Notification of Proposed Modification - Doris North Water Licence 2AM-DOH0713 Part H, Item 1 (Location of Portal)

HBML hereby submits notice of its proposal to revise the location of the portal (the “Portal”) entrance approx. 100m north-north-west from the location originally proposed. The new location is illustrated in the drawings attached to this letter at Appendix A.

Appendix A: Engineering Drawings

Figure 1: Proposed portal face-off area (area denoted by red star), Doris North

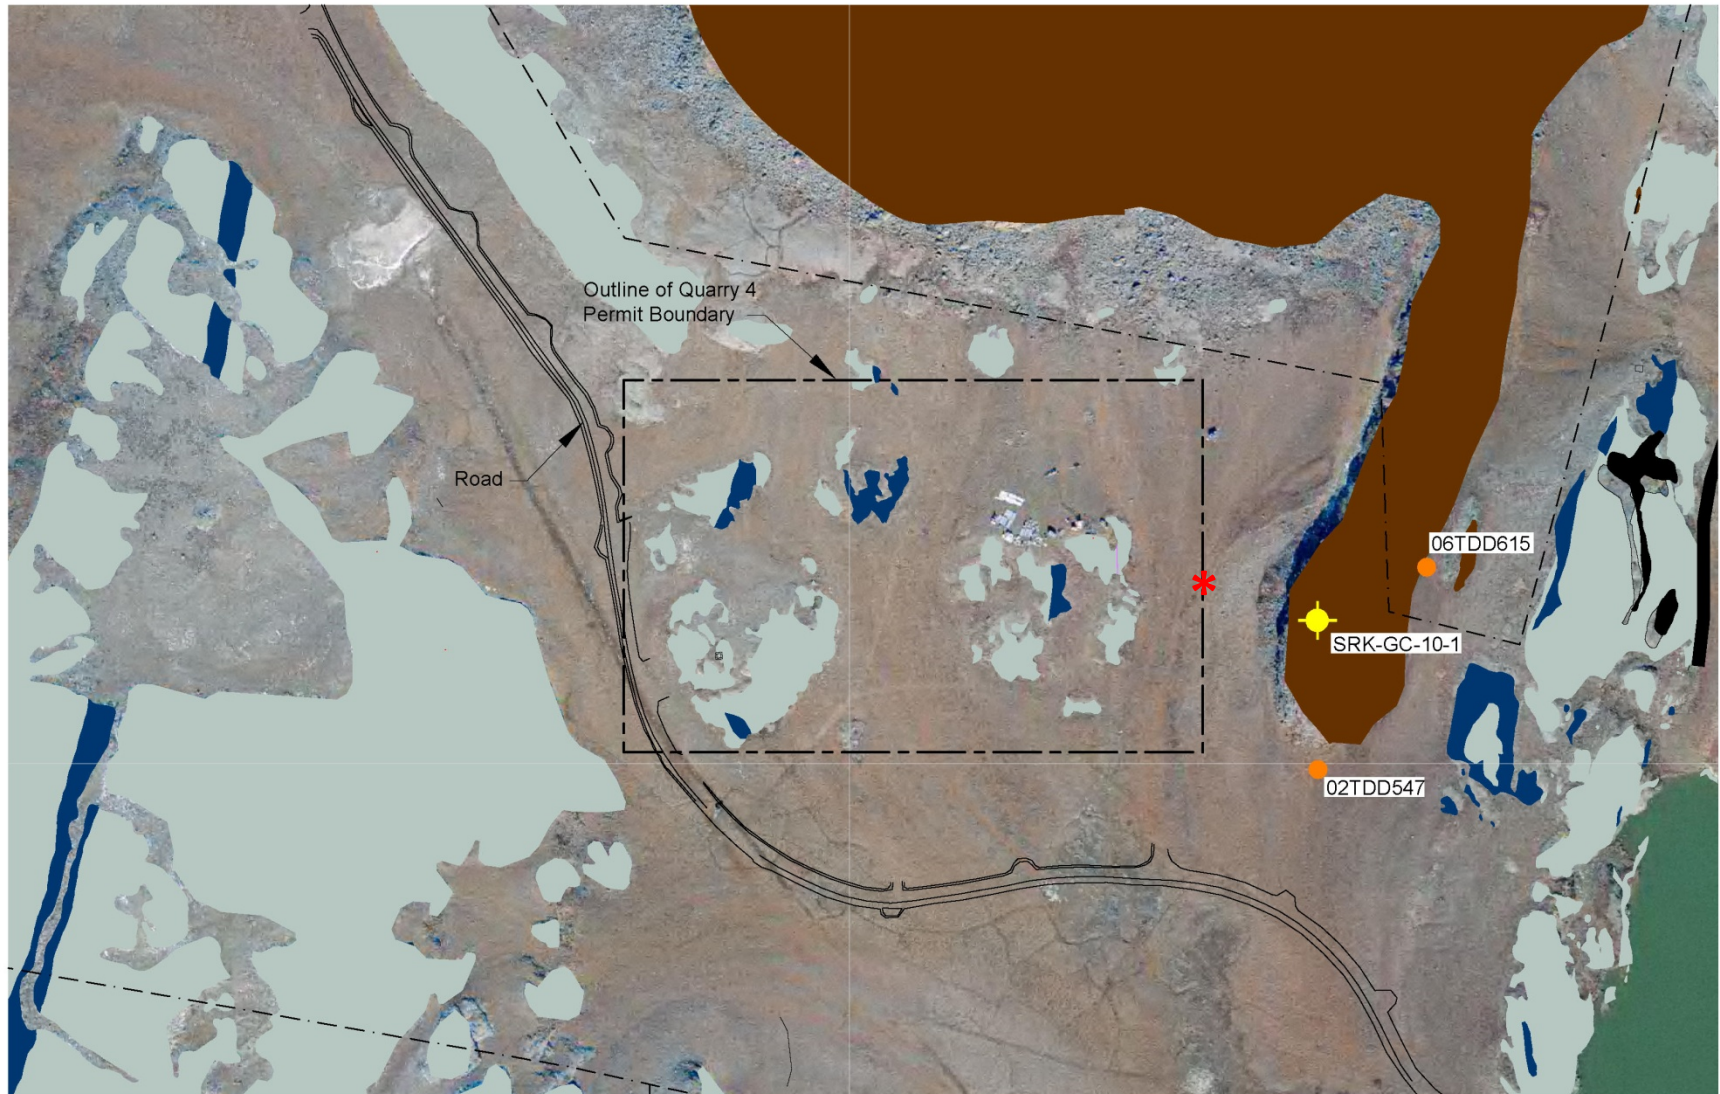
Hope Bay Mining Ltd. (HBML) is planning to start construction of their Doris North mine in 2010, and is currently seeking approval from the Kitikmeot Inuit Association (KIA) for some changes to the currently boundary limits of Quarry 4. These include relocation of the portal, excavation of a rock cut in the portal area and use of the blasted rock to create a pad for other infrastructure requirements. The portal face-off area is to be the primary access portal for the Doris North underground mine (Figure 1). The area of excavation is approximately about 35 m x 100 m and to an approximate depth of 16 m.
